# UNITED STATES PATENT AND TRADEMARK OFFICE

APPLICATION NO.	FILING DATE	FIRST NAMED INVENTOR	ATTORNEY DOCKET NO.	CONFIRMATION NO.
10/087,320	03/01/2002	Andrew H. Cragg	BSI-030US7	3784

# Office Action Summary

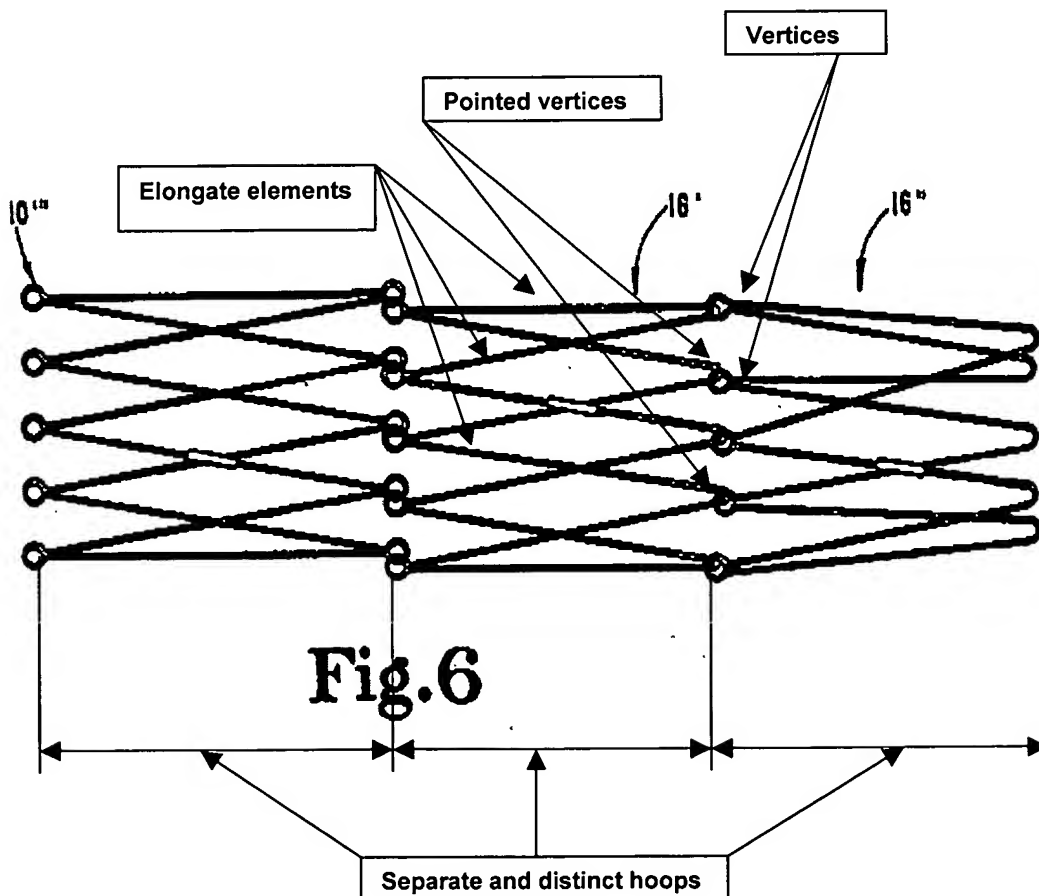
As to claims 10-11, and 13-15, BARONE (Fig. 2-4; column 6, lines 32-45) discloses a stent-graft combination including graft member 160, stent member 166/172 of stainless steel having diamond shaped openings to define elongate elements, with pairs of the elongate elements forming vertices. The vertices axially abut and are individually connected to the opposite pointed vertices. Notice that stainless steel is a resilient and shape memory material. BARONE Fig. 3 also shows graft 160 covers stent 166/172. BARONE does not disclose a stent structure having separate and distinct hoops as recited in the claims. However, to provide a combined stent that permits the combination of several interlocked separate and distinct hoops for insertion into a body passageway without multiple catheterization, GIANTURCO (lines 20-24, col. 2) discloses a stent having separate and distinct hoops and vertices connected together in a manner as recited in the claims and as shown in the Fig. 6 below:

In view of GIANTURCO, it would have been obvious to one of ordinary skill in the art at the time the invention was made to construct a stent-graft combination as claimed by replacing BARONE stent structure with GIANTUREO stent structure of stainless steel so as to provide a longer combined stent of connected shorter stents/hoops, which does not require multiple catheterization (or to avoid a multiple catheterization if the shorter hoops/stents are not connected) for deployment into a blood vessel
